Access Compliance Report

Public Rights-of-Way

(Curb Ramps)

Intersection ID: N/A	Main Street: ARROWOOD_RD	Cross Street: ALTACREST_PL	Location: NE
ADA ID: 13F39F5E36FB	Ramp Type: Directional1	Initial Pass/Fail: Fail	Overall Compliance: No
Severity Score: 1.25			
Codes/Mitigation Info/Possible Solution		Field Measurements/Component Compliance

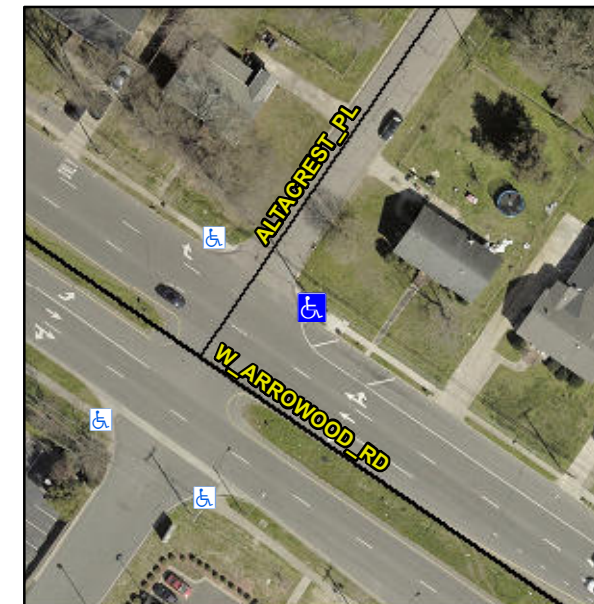
R304.5.3

Compliance	Description	Data	Compliance	Description	Data
N/A	Ramp Length (in)	37.0	N/A	Grade Break?	N/A
Yes	Ramp Width (in)	60.0	N/A	Grade Break Slope (%)	0.0
Yes	Ramp Slope (%)	5.2	N/A	Grade Break XSlope (%)	0.0
No	Ramp XSlope (%)	5.0			
N/A	Flare Type LT	N/A	N/A	Flare Type RT	N/A
N/A	Flare Slope LT (%)	N/A	N/A	Flare Slope RT (%)	0.0
N/A	Flare Traversable LT?	N/A	N/A	Flare Traversable RT?	N/A
N/A	Landing Length (in)	0.0	N/A	DWS Provided?	N/A
N/A	Landing Width (in)	0.0	N/A	DWS Contrast?	N/A
N/A	Landing Slope (%)	0.0	N/A	DWS Length (in)	N/A
N/A	Landing X Slope (%)	0.0	N/A	DWS Full Width?	N/A
N/A	Landing Curb? (Y/N)	N/A	N/A	DWS Offset LT (in)	N/A
N/A	Shared Landing?	N/A	N/A	DWS Offset RT (in)	N/A
N/A	Gutter Ponding?	0.0	N/A	Gutter Slope (%)	N/A
N/A	Gutter Lip Ht (in)	0.0	N/A	Gutter X Slope (%)	N/A
N/A	Painted X Walk1?	No		Road Slope (%)	5.4
	X Walk 1 Direction	To W		Road X Slope (%)	0.0
	X Walk 1 Width (in)	N/A		Clear Space?	N/A

Remove & Replace Entire Ramp.
